Transmitter Functional Symbol Error Histogram (TFSEH) Updated Proposal

IEEE P802.3dj Joint Electrical/Logic/Optical Ad Hoc Teleconference

December 16, 2025

Proposal in review and edit by Author Team & subject to further changes

Figure 180–5—Transmitter $\text{OMA}_{\text{outer}}$ each lane versus max(TECQ, TDECQ) and receiver sensitivity ($\text{OMA}_{\text{outer}}$) each lane versus TECQ

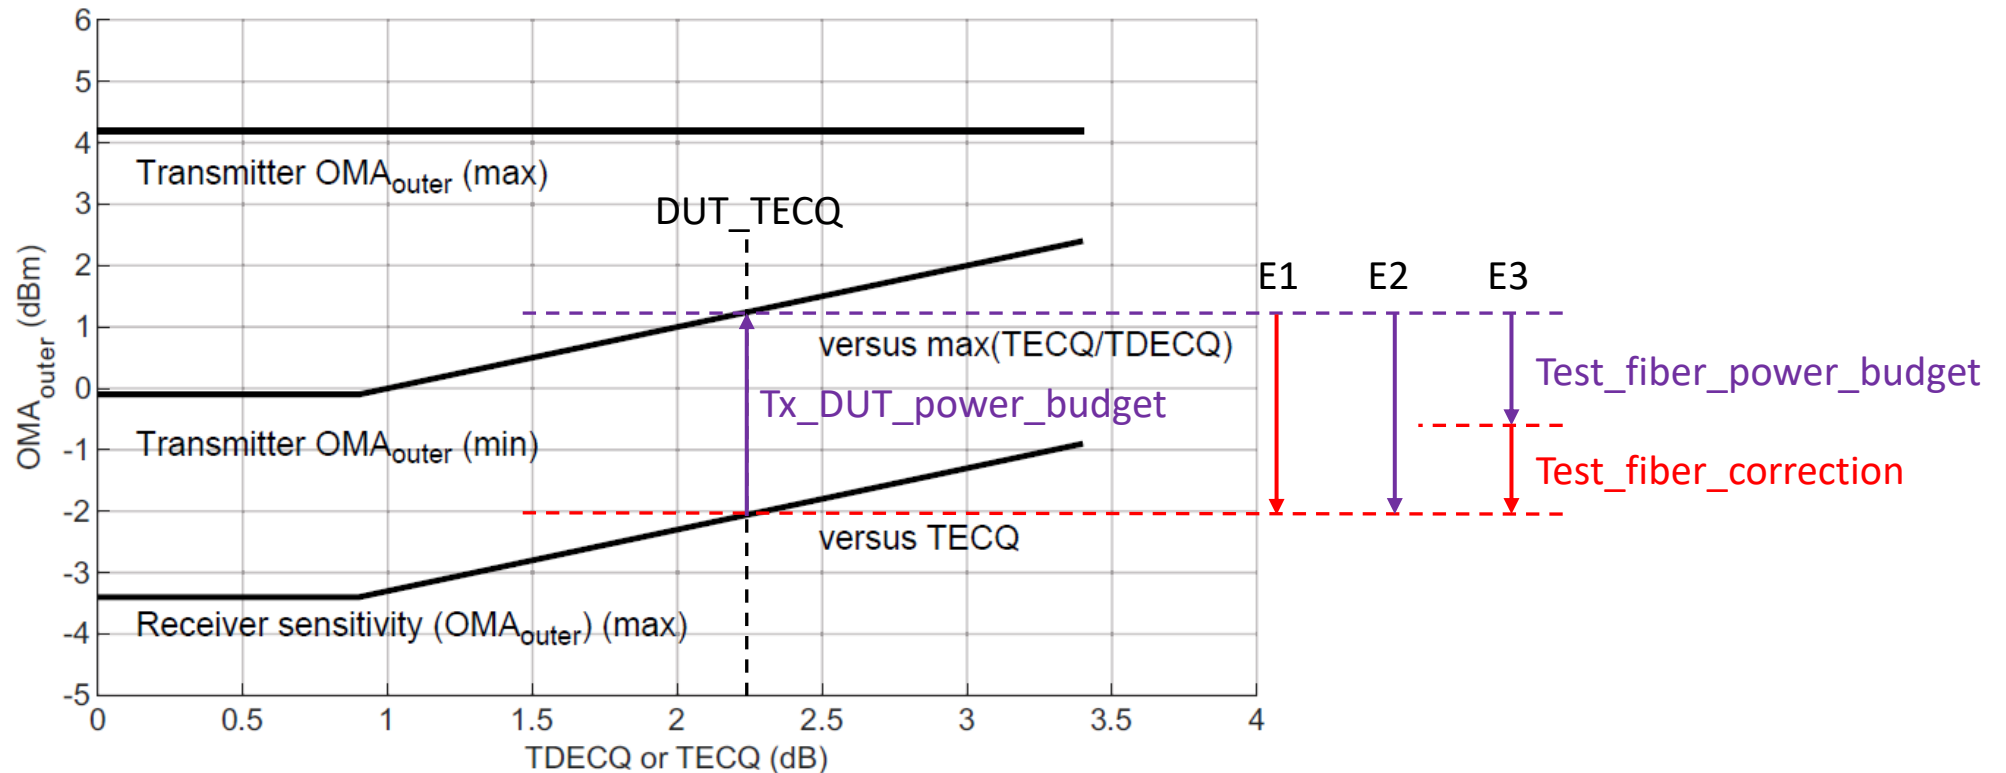
180.9.9.1 Test_fiber_correction exs. using referenced Figure 180-5

$\text{Test_fiber_correction} = \text{Tx_DUT_power_budget} - \text{Test_fiber_power_budget}$ (180-28)

Figure 180-4—Receiver sensitivity (OMA_{outer}), each lane (max)

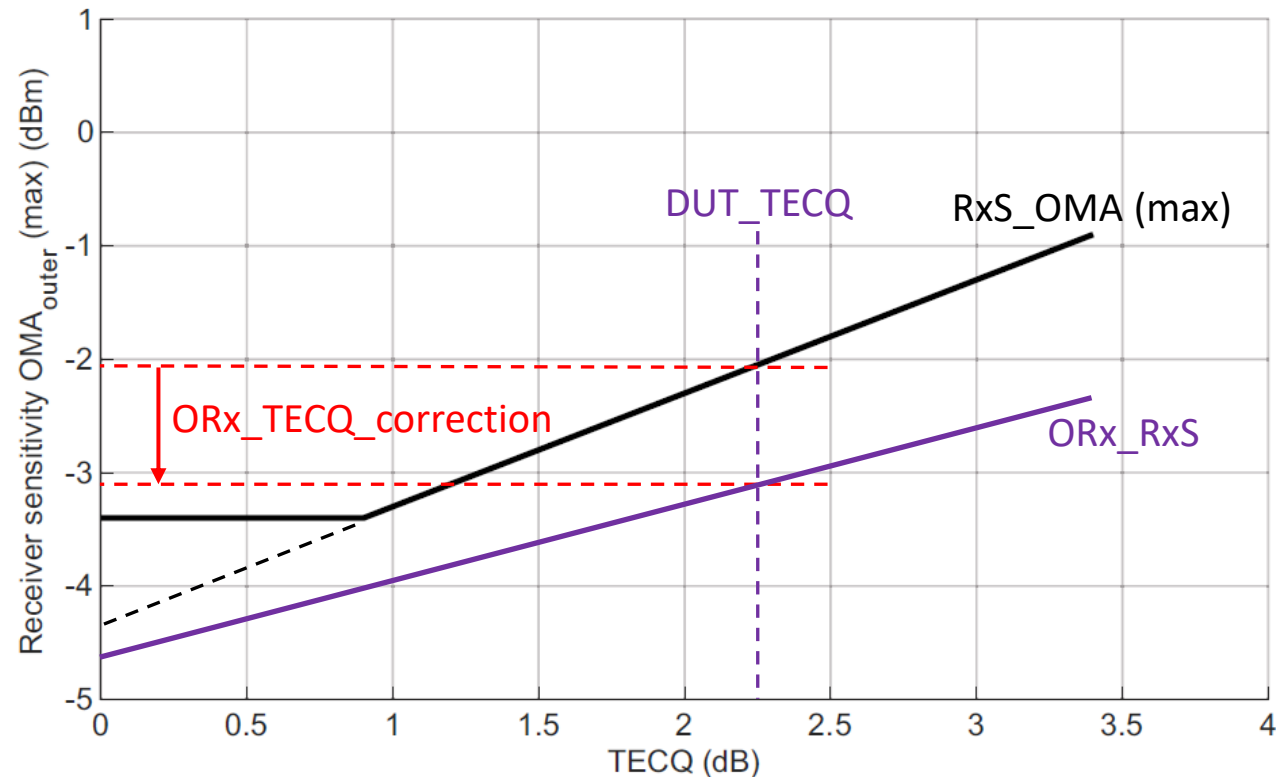
180.9.9.1 ORx_TECQ_correction ex. using referenced Figure 180-4

$$\text{ORx_TECQ_correction} = \text{RxS_OMA@DUT_TECQ} - \text{ORx_RS@DUT_TECQ} \text{ (180-31)}$$

—RxS_OMA@DUT_TECQ is the receiver sensitivity OMA (max) spec for TECQ ≥ 0.9 dB, extrapolated to TECQ = 0 dB (-4.3 dBm), at the TECQ measured for the transmitter under test

—ORx_RxS@DUT_TECQ is the actual ORx receiver sensitivity OMA at the TECQ measured for the transmitter under test

Figure 180–5—Transmitter OMA_{outer} each lane versus max(TECQ, TDECQ) and receiver sensitivity (OMA_{outer}) each lane versus TECQ

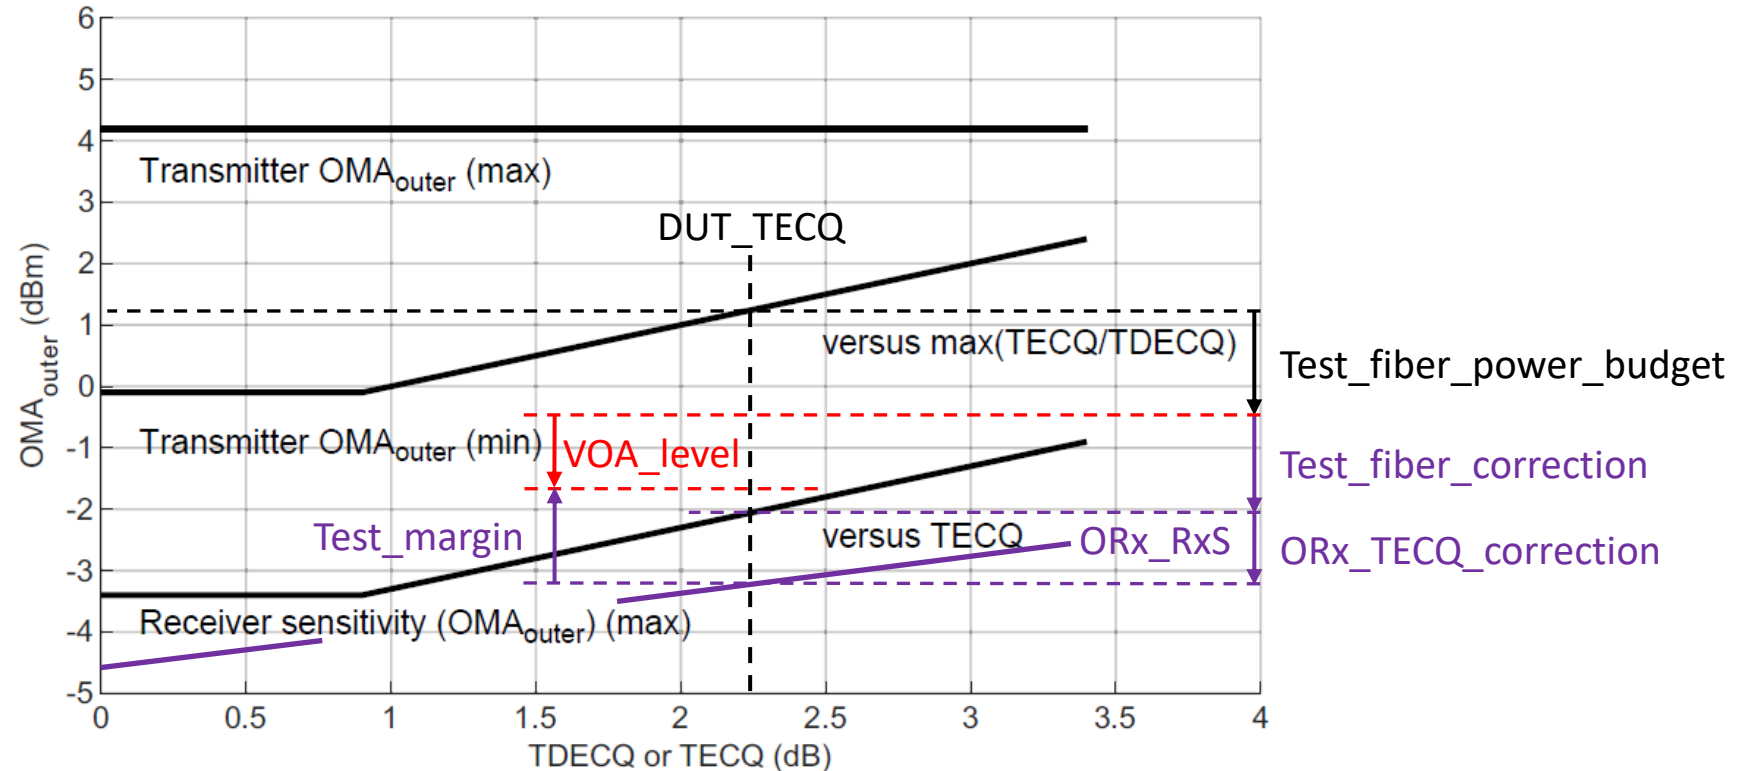
180.9.9.1 VOA_level ex. using referenced Figure 180-5

$$\text{VOA_level} = \text{Test_fiber_correction} + \text{ORx_TECQ_correction} - \text{Test_margin} \quad (180-27)$$

Figure 180–4—Receiver sensitivity ($\text{OMA}_{\text{outer}}$), each lane (max)

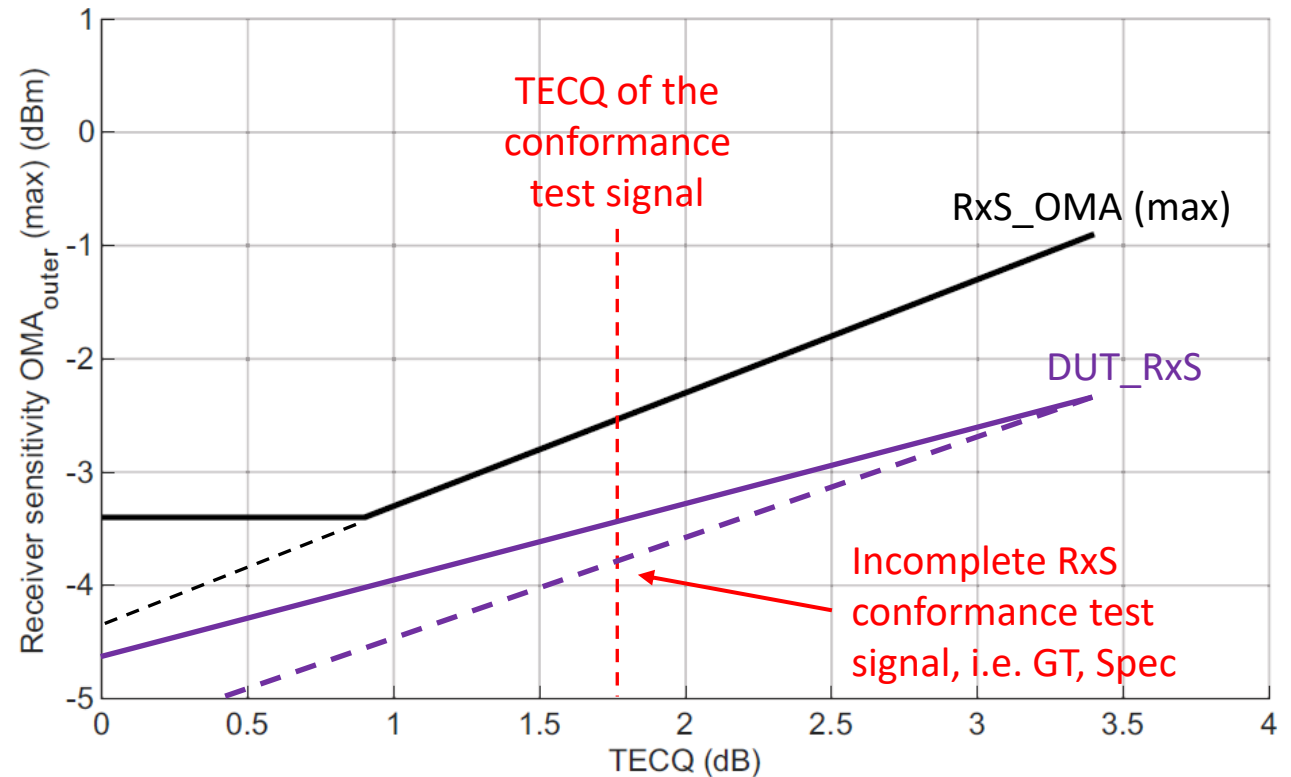
Appendix: Incomplete 180.8.15 RxS Spec found in FRx Testing

The receiver sensitivity ($\text{OMA}_{\text{outer}}$) of each lane shall be within the limits given in Table 180–8 if measured using a test pattern for receiver sensitivity in Table 180–14. The conformance test signal at TP3 meets the requirements for a transmitter followed by an attenuator.

The TECQ of the conformance test signal is measured according to 180.9.6, except that the test fiber is not used. The measured value of TECQ is then used to calculate the limit for receiver sensitivity ($\text{OMA}_{\text{outer}}$) as specified in Table 180–8.

The receiver sensitivity ($\text{OMA}_{\text{outer}}$) of each lane shall be within the limits given in Table 180–8 if measured using a test pattern for receiver sensitivity in Table 180–14. ~~The conformance test signal at TP3 meets the requirements for a transmitter followed by an attenuator.~~

The conformance test signal at TP3 is the stressed receiver sensitivity test signal, specified in 180.9.16, except that the Gaussian noise generator and sinusoidal interferer are both turned off (the sinusoidal jitter remains on).

The stressed receiver sensitivity conformance test signal, specified in 180.9.16, needs additional review to confirm it is worst-case stress. For example, the sinusoidal jitter specification is ambiguous.
